Design Memorandum No. 17-03
Technical Advisory

March 1, 2017

SUBJECT: Mechanically Stabilized Earth (MSE) Walls

REVISES: *Indiana Design Manual* Sections 402-6.02(02), 409-2.04(02), 409-3.03,
Figure 409-2G, and Figure 410-5(0)C (new)

**Figure 409-2G
(Sheet 1 of 2)**

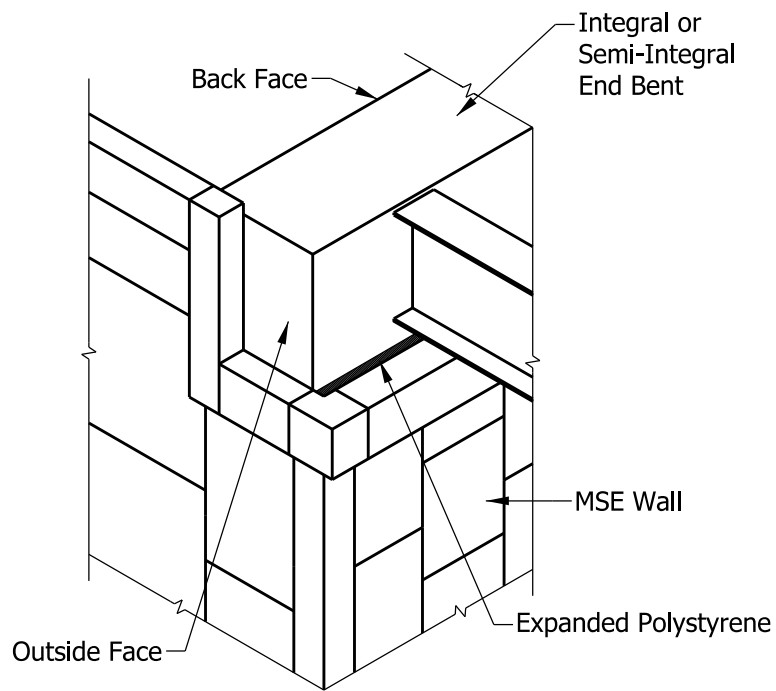
IDM 409-2.04(02) Integral End Bent – Design Requirements, 409-3.03 Semi-Integral End Bent, and Figure 409-2G Figure 409-2G illustrates the minimum distance from the edge of the pile sleeve to the back of the MSE wall panel and preferred MSE wall configurations at an end bent.

- d. Where utilizing an MSE retaining wall at an end bent, a minimum distance of 3 ft. is required between the back of the wall panel and the edge of the pile sleeve or the pile (where sleeves are not required). For determining preliminary structure span length, a 24-in pile sleeve should be assumed. The need for pile sleeves will be determined by the Office of Geotechnical Services. *LRFD* 11.10.11 provides additional information regarding the placement of obstructions in the reinforced soil zone.

11. MSE Wall. If placed behind an MSE retaining wall, the end bent should be configured as shown in Figure [409-2G](#). See *LRFD* 11.10.8 and Section 410-5.0(07) of this manual for MSE wall drainage information.

If placed behind an MSE retaining wall, the end bent should be configured as shown in Figure [409-2G](#). See *LRFD* 11.10.8 and Section 410-5.0(07) of this manual for MSE wall drainage information.

MSE Wall at an End Bent. When an end bent is placed behind an MSE wall, expanded polystyrene should be shown for gap between the front face of the end bent and the back of the MSE wall. Do not show Styrofoam or extruded polystyrene. See Figure 409-2G, End Bent Placed behind MSE Wall for additional details.

Coarse aggregate and 6" end-bent drain pipe are not required to be specified separately for an end bent placed behind an MSE Wall.

Figure 409-2G
(Sheet 2 of 2)

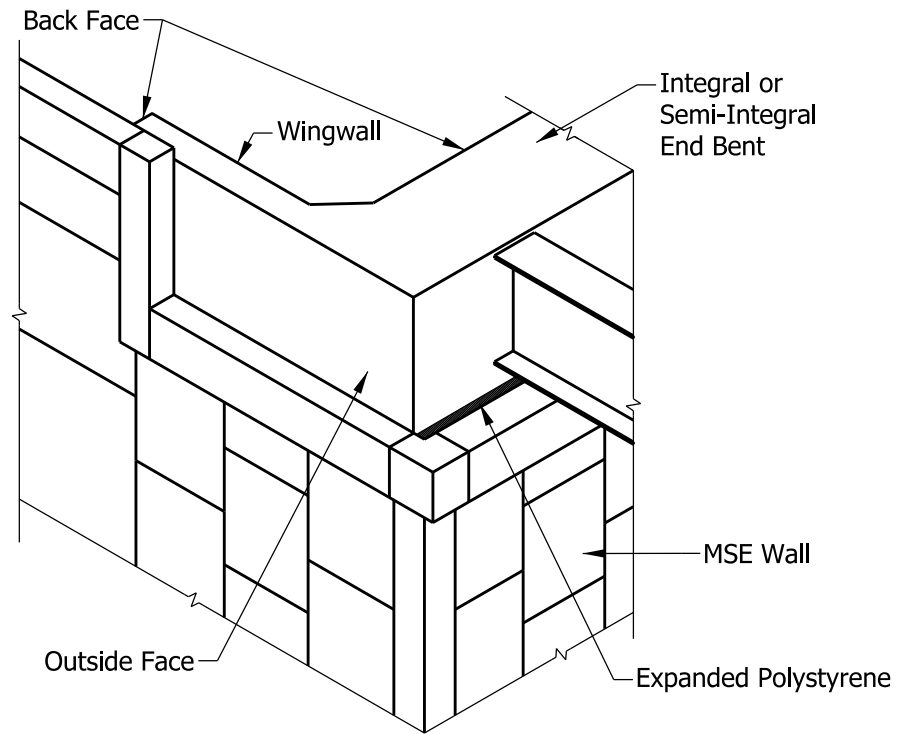
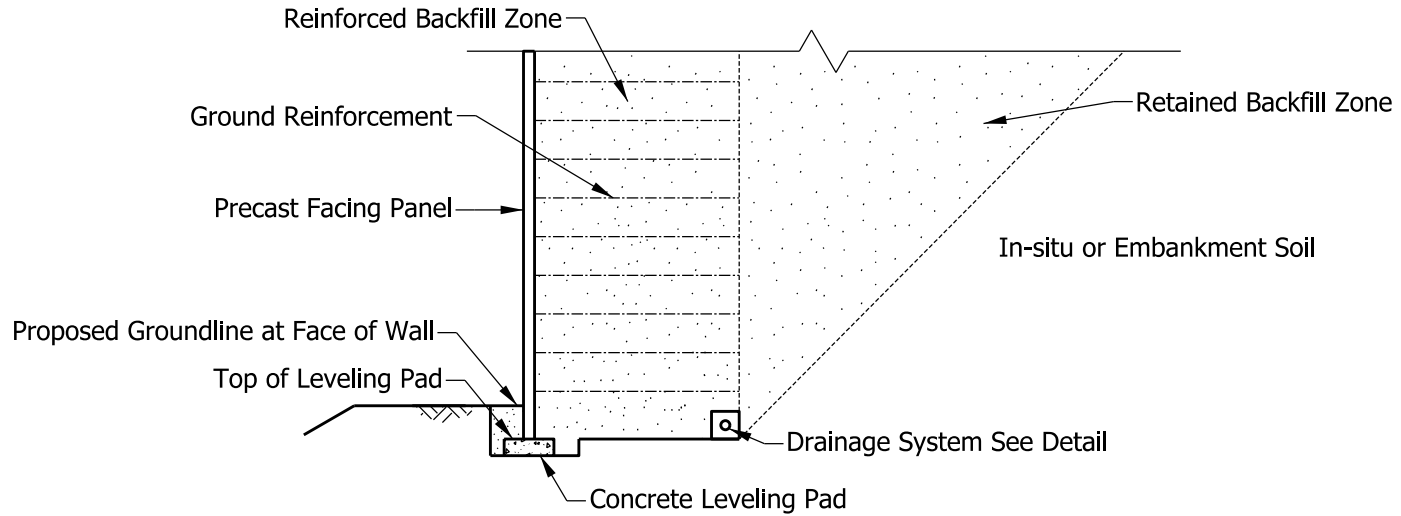
Where an MSE is placed parallel to the bridge approach roadway, it should be placed adjacent the outside face of the end bent or wingwall, but not cast against it. Sufficient clearance is needed to accommodate the thermal movement of the end bent. The MSE wall should not be placed abutting the back face of the end bent or wingwall.

Figure 410-5(0)C

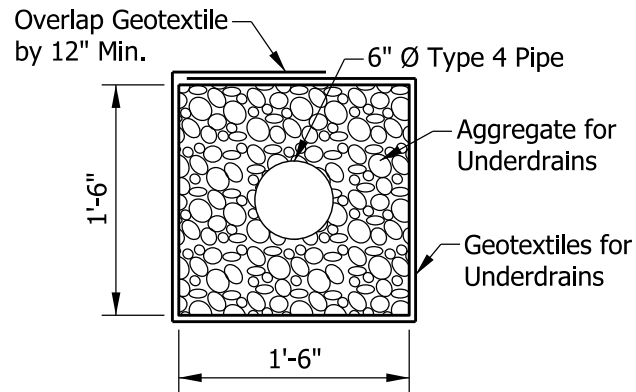
- Drainage systems are required for all MSE walls. Figure 410-5(0)C illustrates a typical MSE wall cross sections and provides the drainage details to be included on plans.
- A plan view showing all obstructions and their offset from the back of the MSE wall is required on the MSE Wall Details sheet. Obstructions include but are not limited to, piles, pile sleeves, catch basins, signal or sign foundation, guardrail posts, and culverts. Where an obstruction projects through the MSE wall panel, the obstruction should also be shown in an isolated section and elevation view.
- Modifications to the wall design to avoid obstructions must be shown in the MSE Wall working drawings. Design options for obstructions within the reinforced zone are described in the *AASHTO LRFD Bridge Design Specifications*, section 11.10.10.4.

Figure 410-5(0)C shows the typical cross section of an MSE wall.

Drainage. Details for drainage of the surface-water infiltration and reinforced-soil backfill should be included for all MSE walls. Figure 410-5(0)C shows the standard drainage details. It is the designer's responsibility to determine the elevation of the drainage pipe such that it will drain and outlet adequately.
